# HISTORIC AND DESIGN REVIEW COMMISSION

**HDRC CASE NO:** 2024-379  
**ADDRESS:** 114 DEWBERRY ST  
**LEGAL DESCRIPTION:** NCB 6461 (MISTLETOE ADDITION SUBDIVISION), BLOCK 1 LOT 57  
**ZONING:** R-4, H  
**CITY COUNCIL DIST.:** 1  
**DISTRICT:** River Road Historic District  
**APPLICANT:** Joseph Keresztury/True Stone Custom Homes, LLC  
**OWNER:** Stephanie Pina/PINA DANIEL & STEPHANIE  
**TYPE OF WORK:** New Construction  
**APPLICATION RECEIVED:** January 15, 2025  
**60-DAY REVIEW:** March 16, 2025  
**CASE MANAGER:** Caitlin Brown-Clancy

The applicant is requesting a Certificate of Appropriateness to construct a new 2-story, single-family residence totaling approximately a 2,400 sf building footprint with an attached porte cochere.

## SITE PLAN

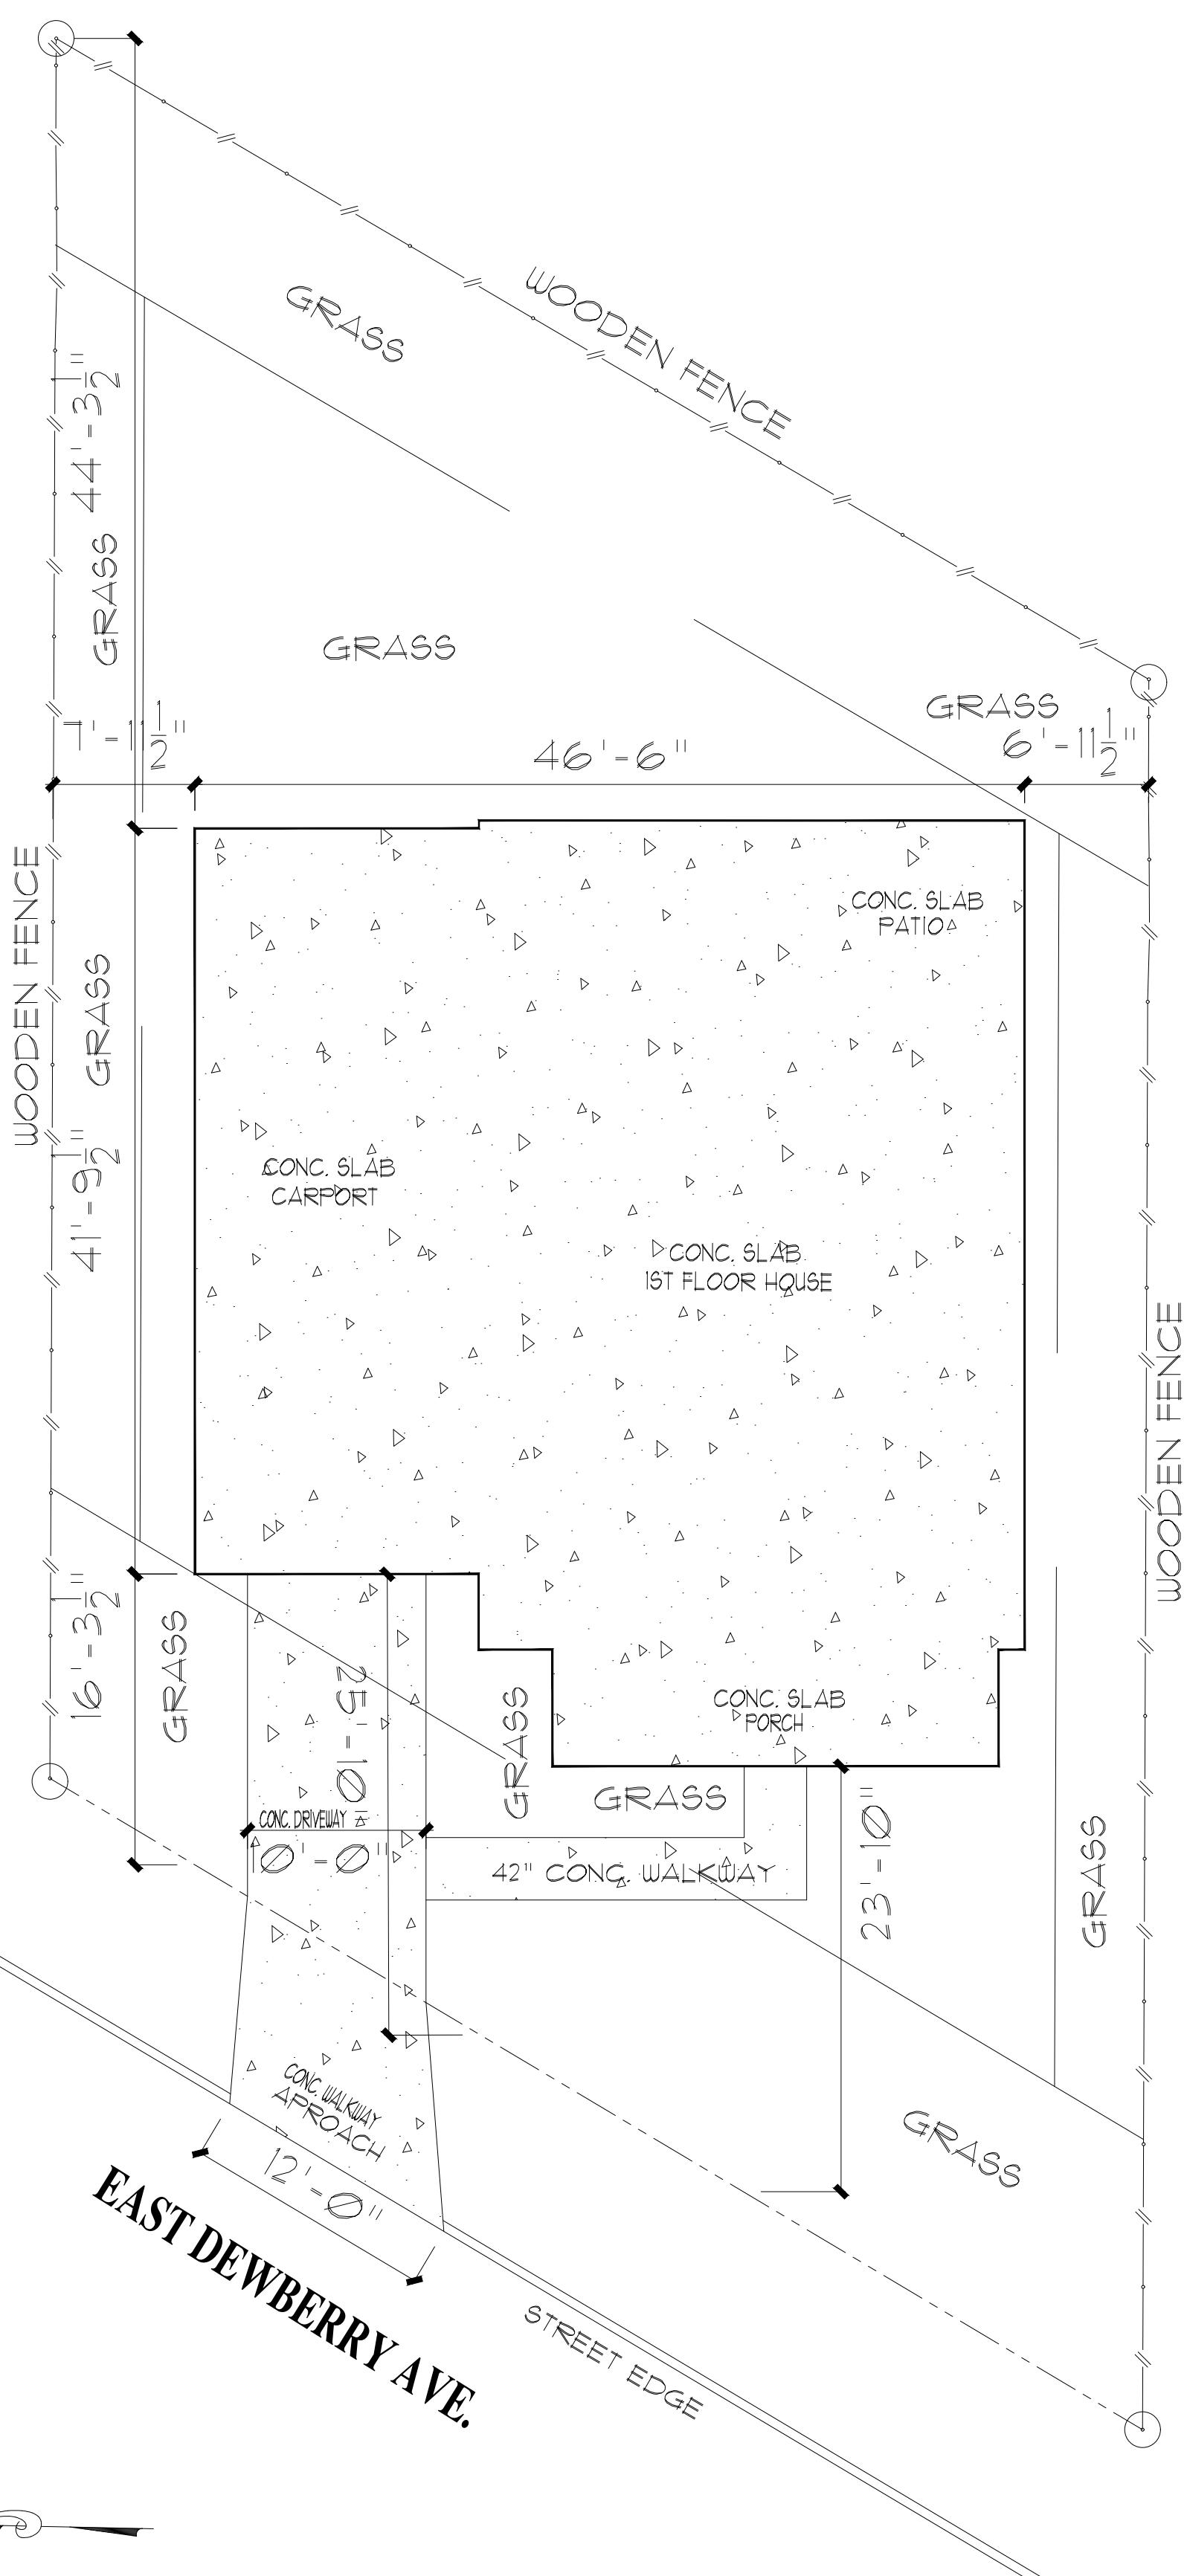
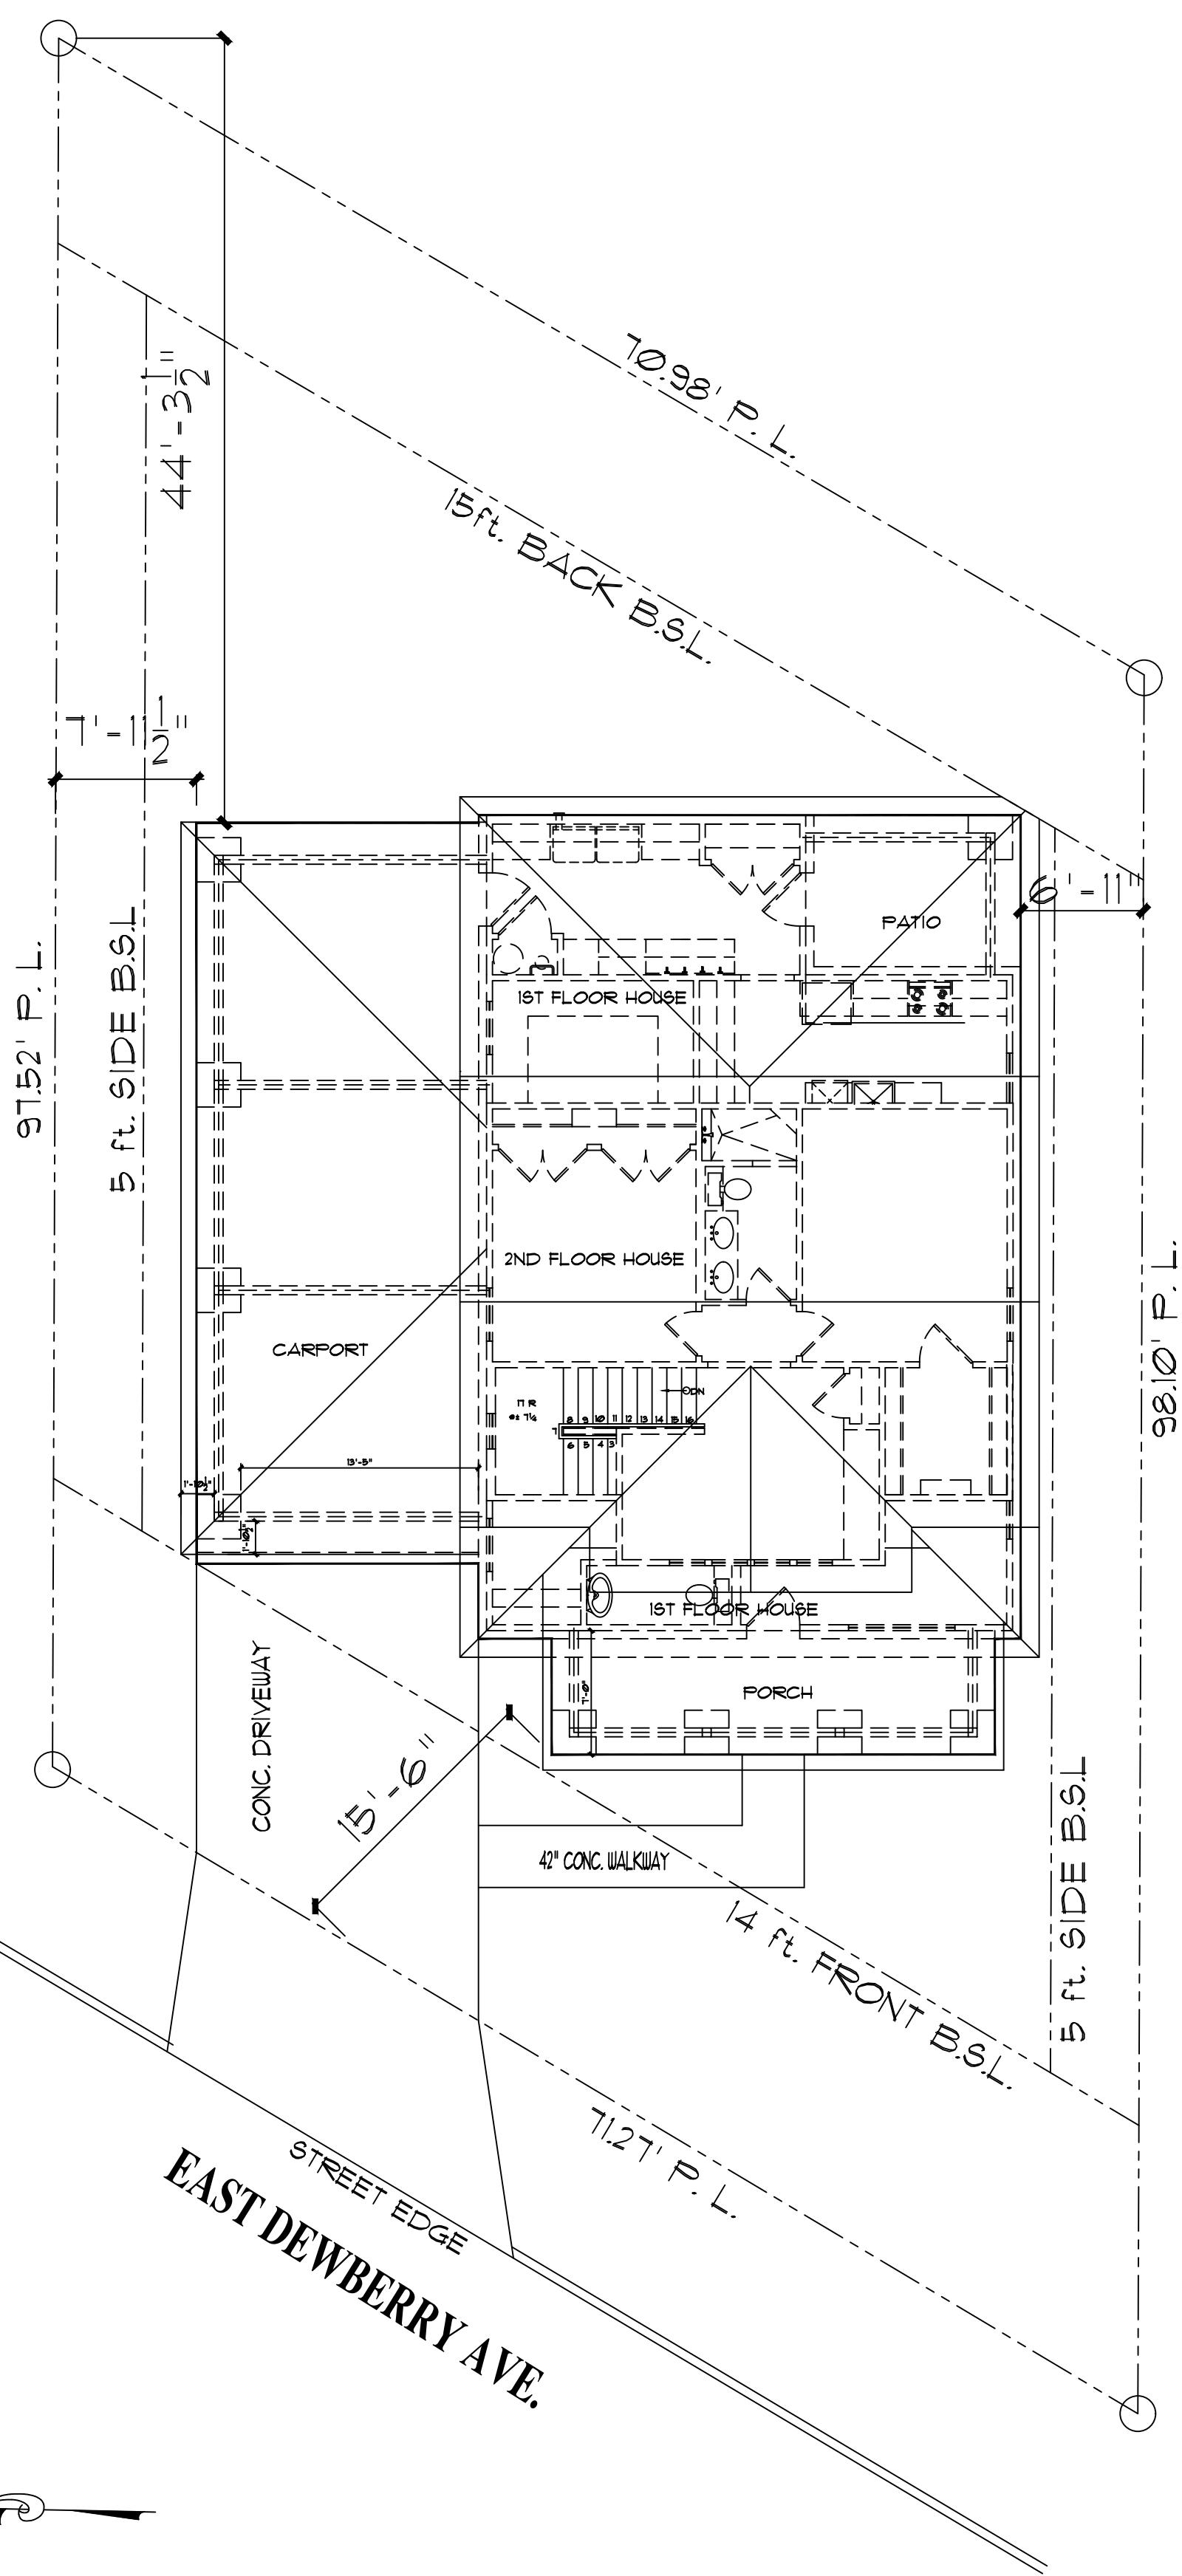
- p. DRIVEWAYS – The applicant has proposed one driveway but has not submitted a site plan with measurements. Staff finds the applicant should submit a measured site plan indicating driveway location, design, and curb cuts to be submitted to Staff prior to final approval.

Sec. 35-516(e) of the Unified Development Code permits irregular shaped lots to have a reduced setback, so long as the mean horizontal rear setback is at least 15 feet.

I believe this is the case per the Site Plan you provided and if that is the case, you do not require this variance.

2. That the applicant submits a measured site plan communicating the driveway location, design, and curb cuts, a landscaping plan, and exterior door specifications as noted in findings k and n. **THIS STIPULATION HAS BEEN MET**
